MARK UP 2/7/96

CUSTOMER SPEC. : VO49-2-002

DO NOT SCALE DRAWING		THIS DRAWING INCLUDING THE INFORMATION, DATA, AND DESIGN IS THE PROPERTY OF EDWARDS HIGH VACUUM INC. IT IS NOT TO BE COPIED, REPRODUCED, OR ITS CONTENTS DISCLOSED WITHOUT THE WRITTEN PERMISSION OF EDWARDS.	
EDWARDS HIGH VACUUM INTERNATIONAL GRAND ISLAND, NEW YORK 14072 A Division of the BOC Group, Inc.			
No.	Revision	Date	By
1	YS	12-28-95	
Checked	Scale	1/8"=1.00	
Approved	RFQ No.	8490	
Non-Std No.	NG8050100	Dwg. No.	D-4507-A
Customer	PSI

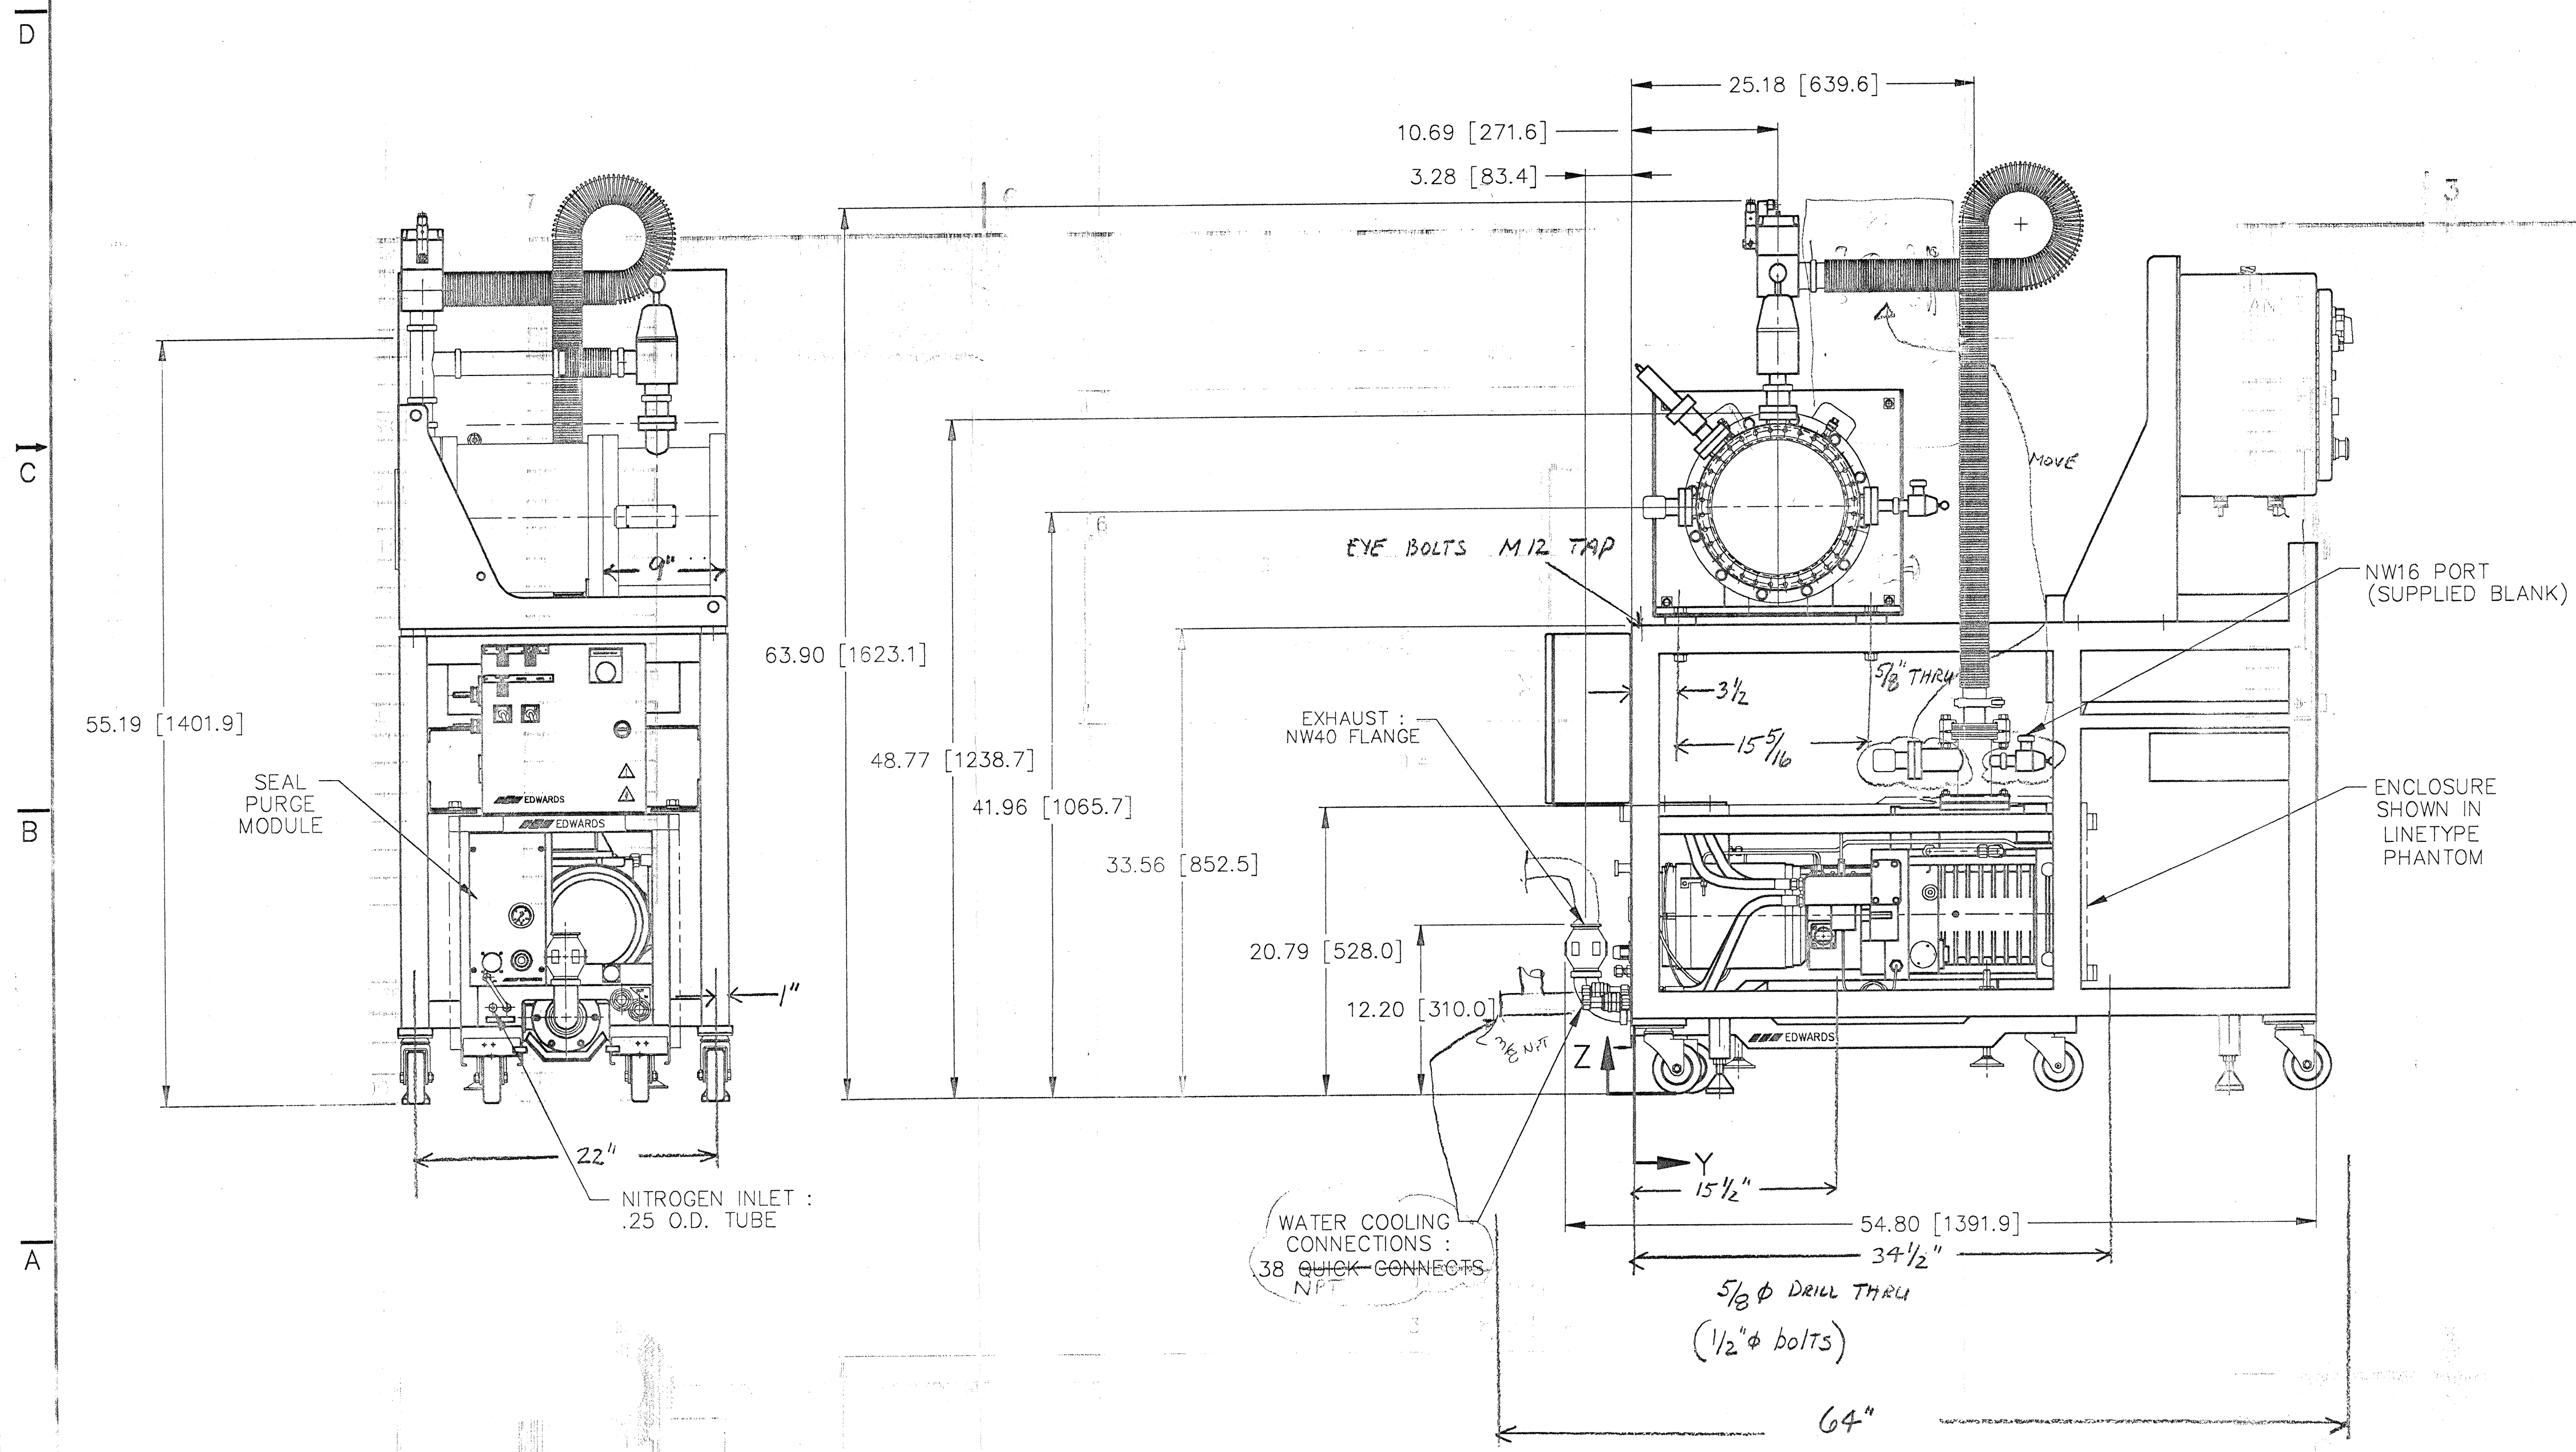
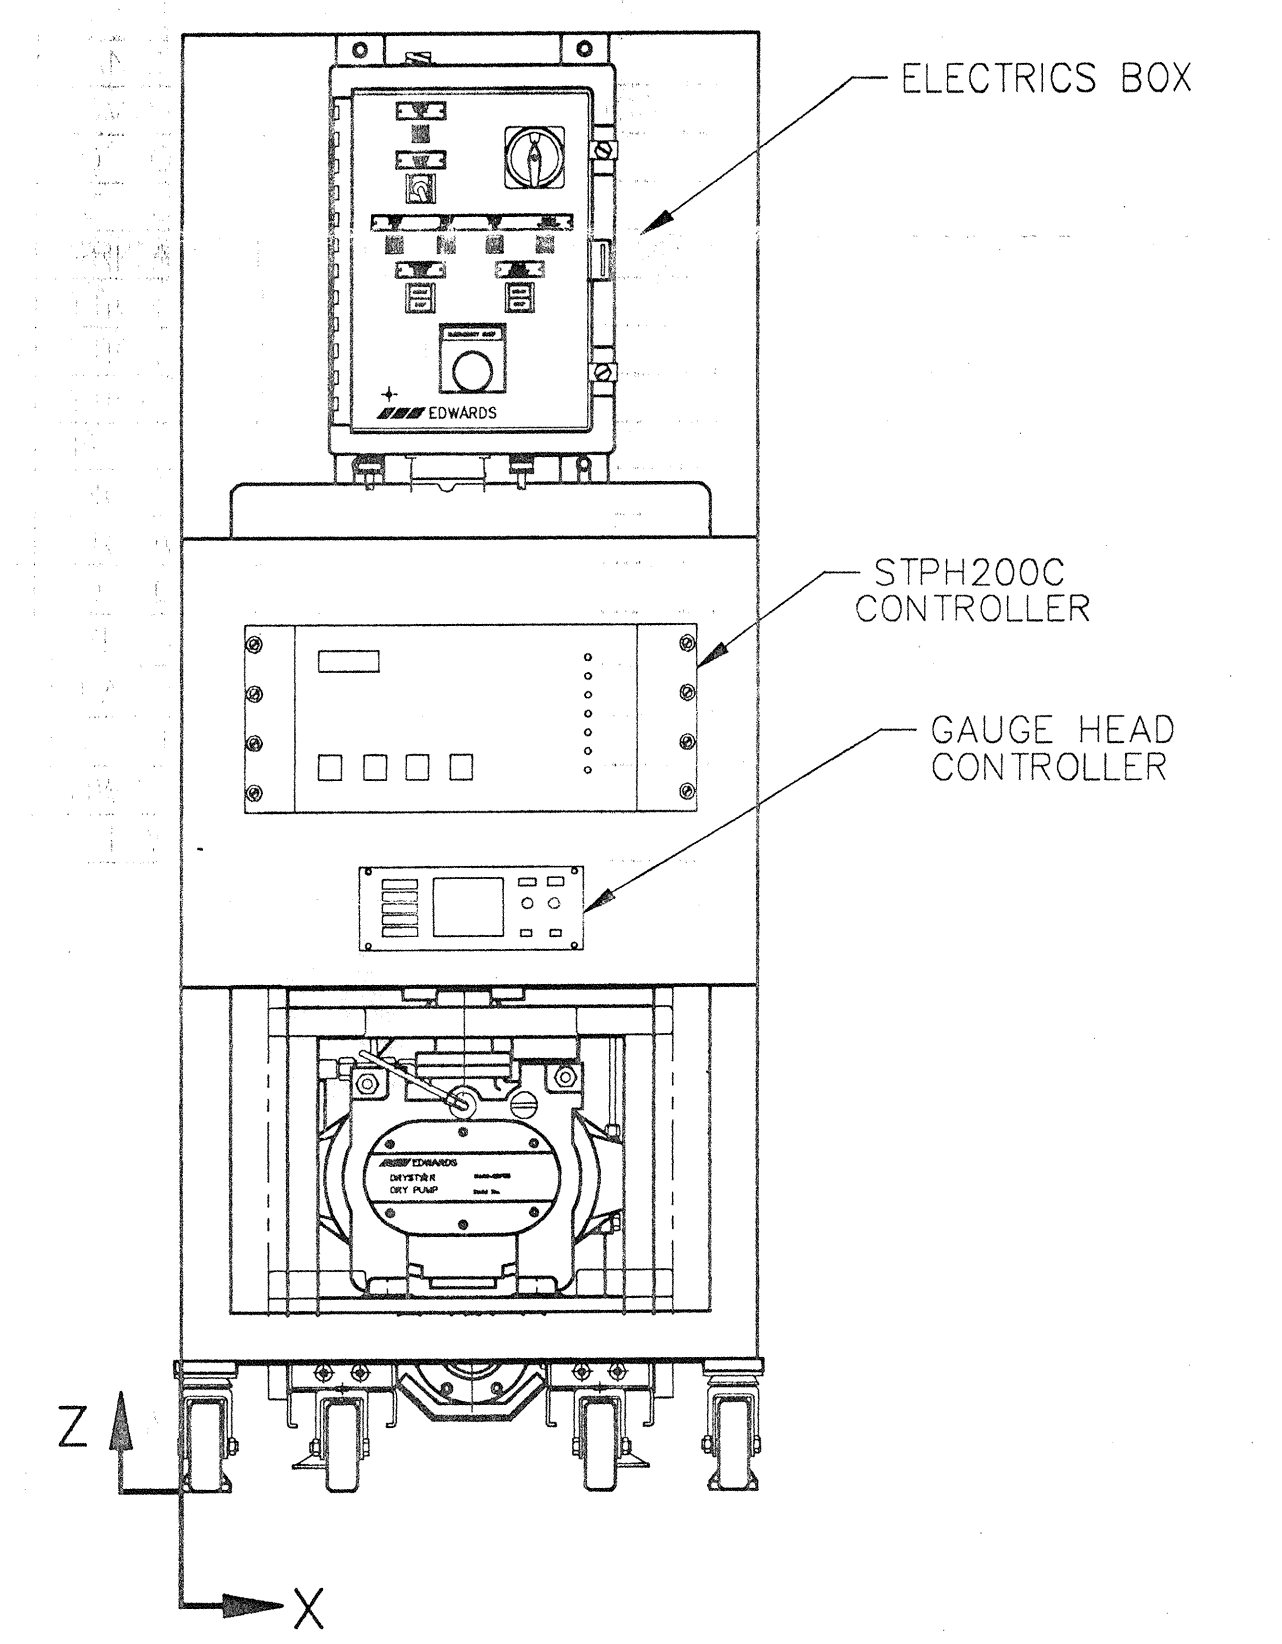
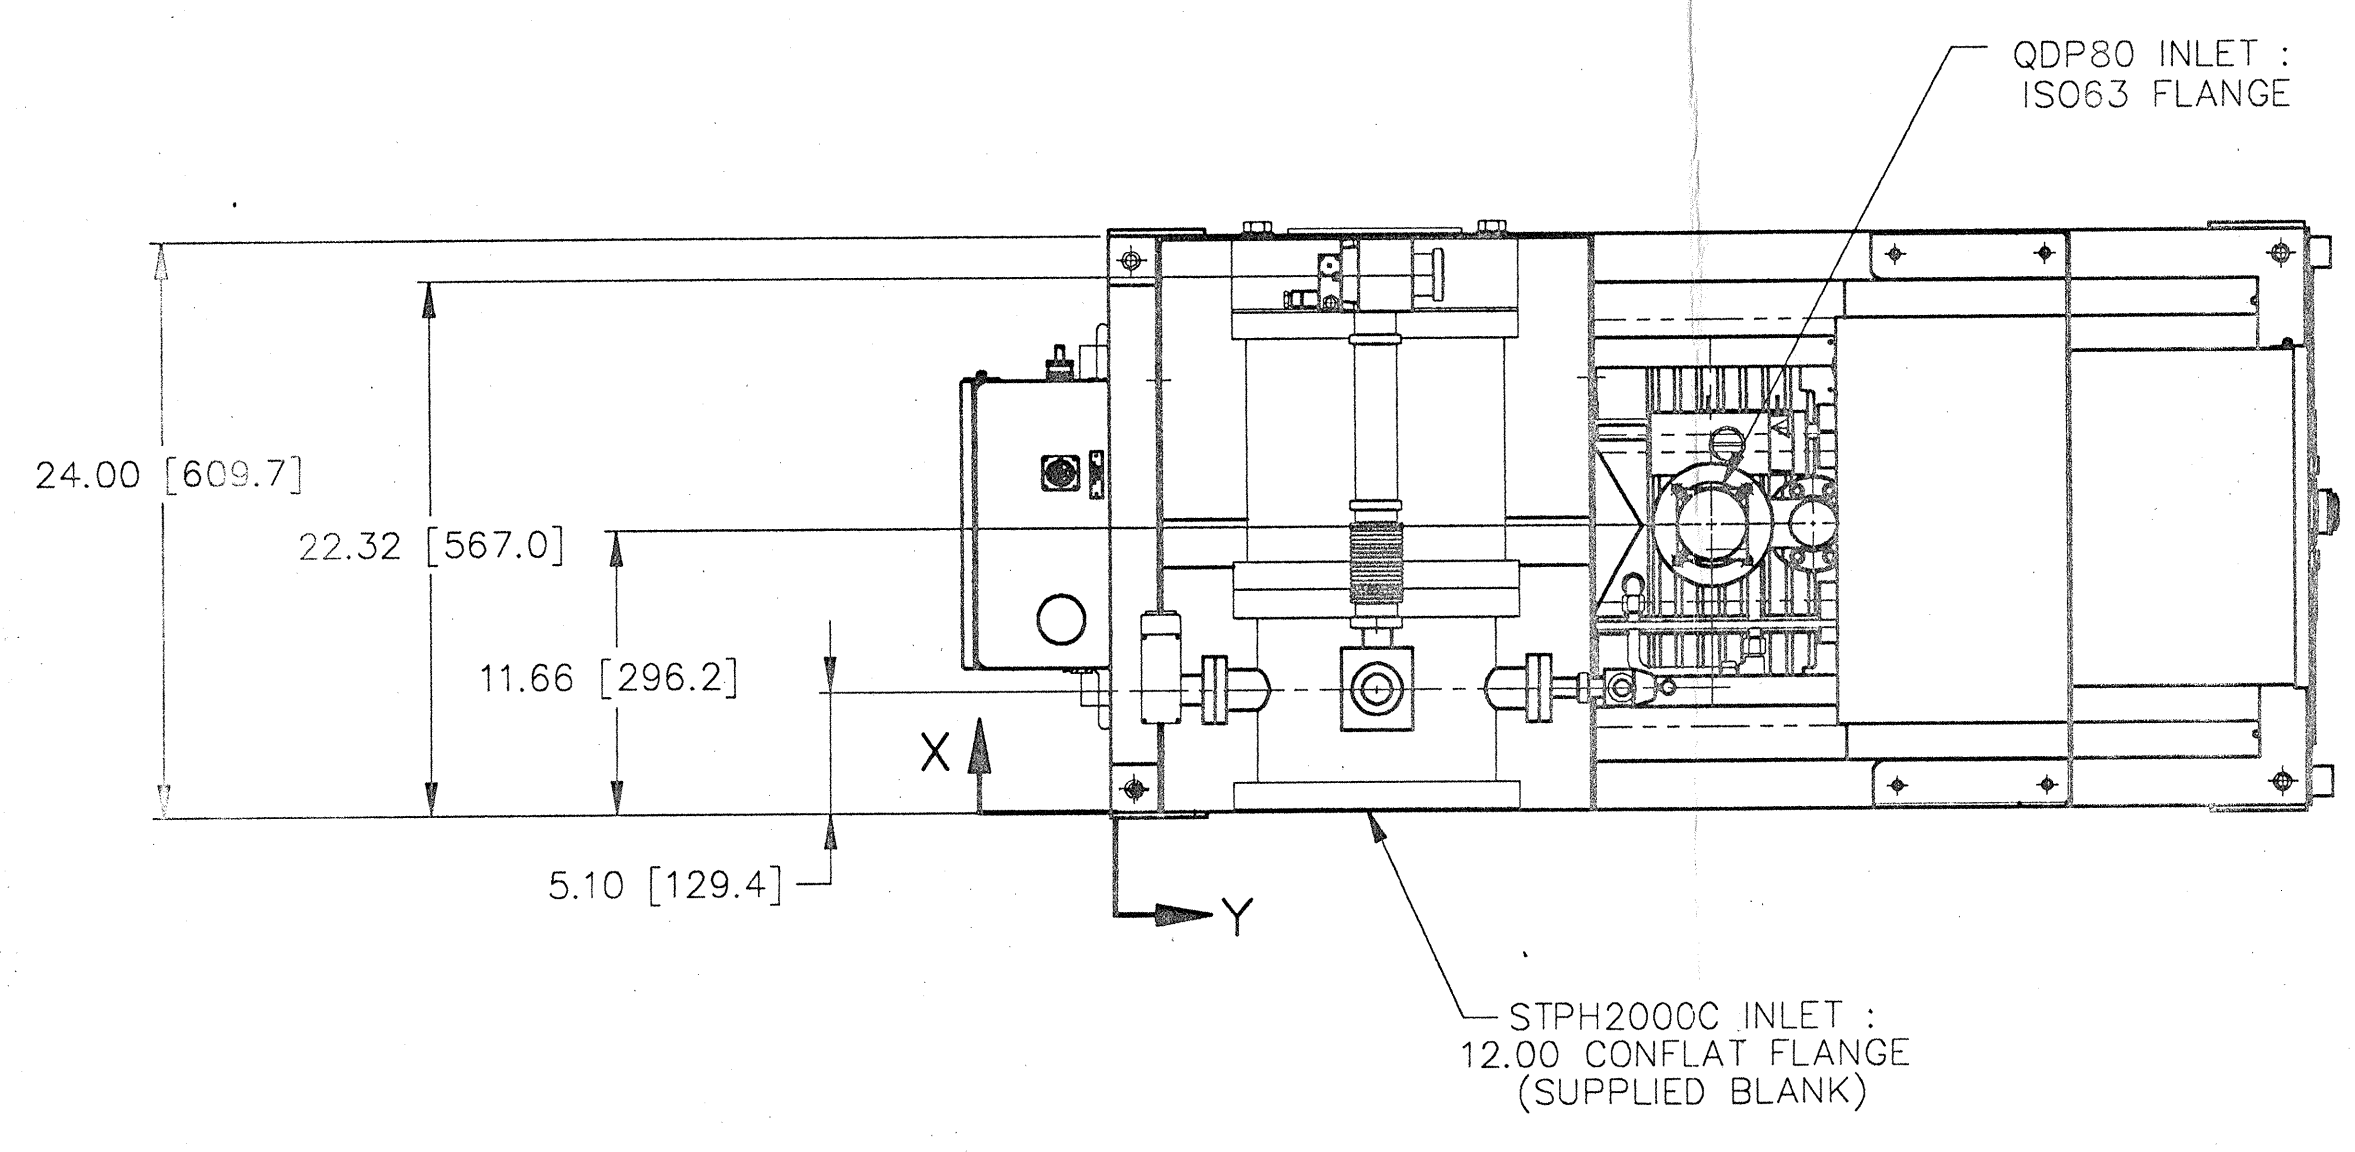
DRAFT : DIMENSION PRINT ONLY
